Access Compliance Report

Public Rights-of-Way

(Curb Ramps)

Intersection ID: 27478	Main Street: BALLANTYNE_MEADOWS_DR	Cross Street: BLUE_CEDAR_LN	Location: SW
ADA ID: C213DEE70EB5	Ramp Type: PerpDiag	Initial Pass/Fail: Fail	Overall Compliance: No
		Severity Score: 37.5	
Codes/Mitigation Info/Possible Solution		Field Measurements/Component Compliance

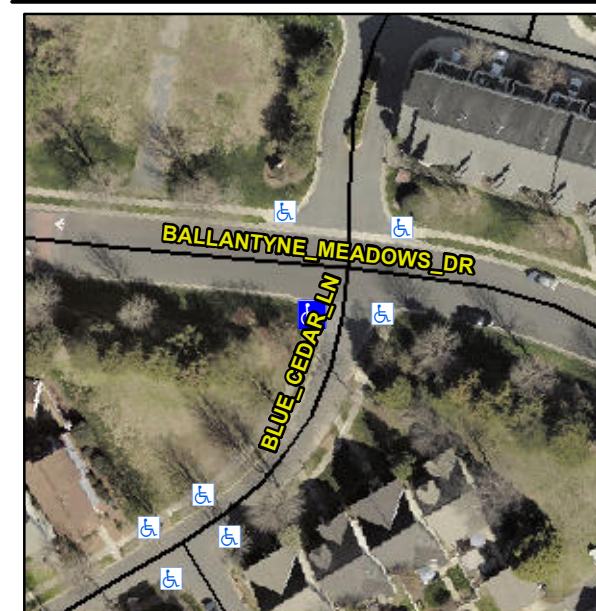
R304.2.2, R304.5.3

Compliance	Description	Data	Compliance	Description	Data
N/A	Ramp Length (in)	60.0	No	Ramp Slope (%)	11.8
Yes	Ramp Width (in)	48.0	No	Ramp XSlope (%)	7.0
N/A	Flare Type LT	N/A	N/A	Flare Type RT	N/A
N/A	Flare Slope LT (%)	N/A	N/A	Flare Slope RT (%)	N/A
N/A	Flare Traversable LT?	N/A	N/A	Flare Traversable RT?	N/A
N/A	Landing Length (in)	N/A	N/A	DWS Provided?	N/A
N/A	Landing Width (in)	N/A	N/A	DWS Contrast?	N/A
N/A	Landing Slope (%)	N/A	N/A	DWS Length (in)	N/A
N/A	Landing X Slope (%)	N/A	N/A	DWS Full Width?	N/A
N/A	Landing Curb? (Y/N)	N/A	N/A	DWS Offset (in)	N/A
N/A	Shared Landing?	N/A			
N/A	Gutter Ponding?	N/A	N/A	Gutter Slope (%)	N/A
N/A	Gutter Lip Ht (in)	N/A	N/A	Gutter X Slope (%)	N/A
N/A	Painted X Walk1?	No	N/A	Painted X Walk2?	No
	X Walk 1 Direction	To E		X Walk 2 Direction	To N
N/A	X Walk 1 Width (in)	N/A	N/A	X Walk 2 Width (in)	N/A
	X Walk 1 Slope (%)	3.8		X Walk 2 Slope (%)	2.0
	X Walk 1 X Slope (%)	3.4		X Walk 2 X Slope (%)	5.0

N/A	Ramp inside XWalk1?	N/A	N/A	Ramp inside XWalk2?	N/A
	Road Slope (%)	4.3	N/A	Clear Space?	N/A
	Road X Slope (%)	2.8	N/A	Clear Space to XWalk (in)	N/A
N/A	Any Obstructions?	N/A	N/A	Storm Grate/Utility Hazard?	N/A
	Obstruction Type			Storm Grate/Utility Type	
		N/A			N/A
		Yes		Surface Condition? (G/P)	Good

Remove & Replace Curb Ramp With Two New Directional Ramps or Equivalent.
